ADDENDUM NO. 3

MEMORIAL OPERA HOUSE – BID PACKAGE #3 – INTERIORS PACKAGE

This Addendum forms a part of and modifies the Bidding Requirements, Contract Forms, Contract Conditions, the Specifications, and the Drawings dated January 12, 2024 by Schmidt Associates. Acknowledge receipt of the Addendum in the space provided on the Bid Form. Failure to do so may subject the Bidder to disqualification.

5.4.603 - DOOR FRAME ELEVATIONS
1/4" = 1'-0"

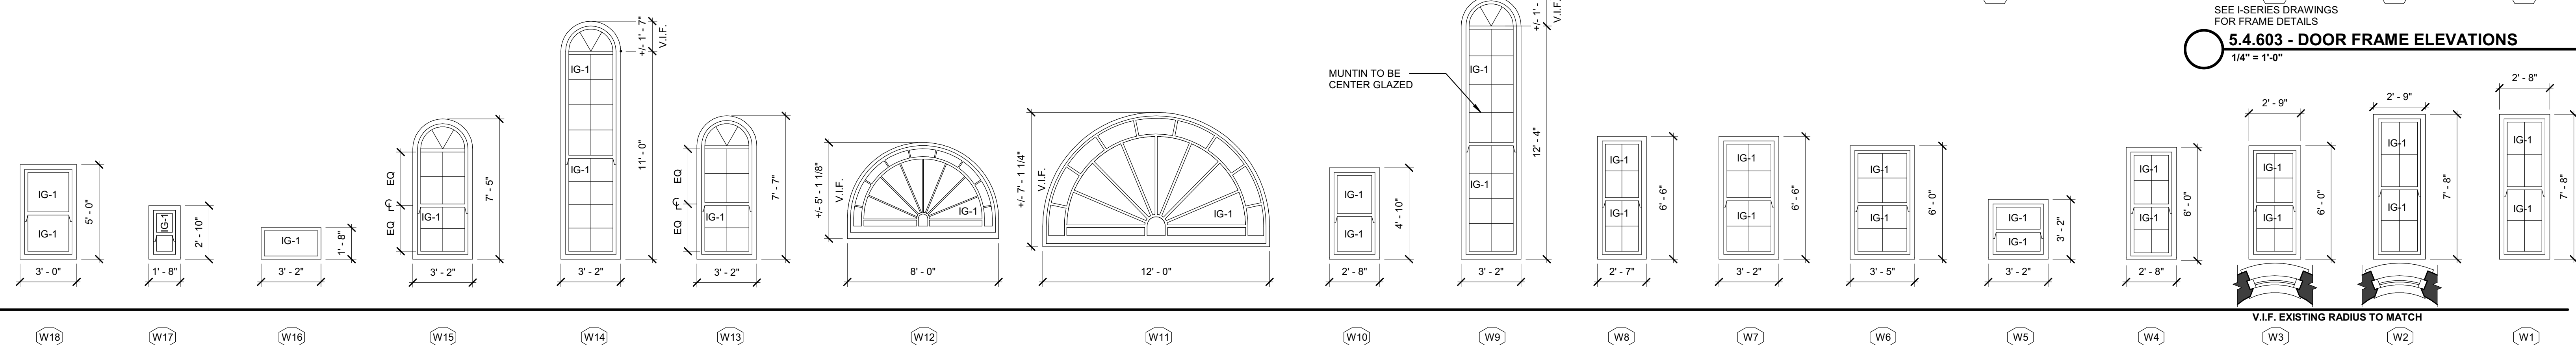
Reference included drawing sheets A600.2 and AF101.2; the **Bid Category No. 7 Contractor** shall include the wood trim referenced in door frame elevation “F4” and as indicated in detail 3A/Sheet I-210.3 of the construction documents.
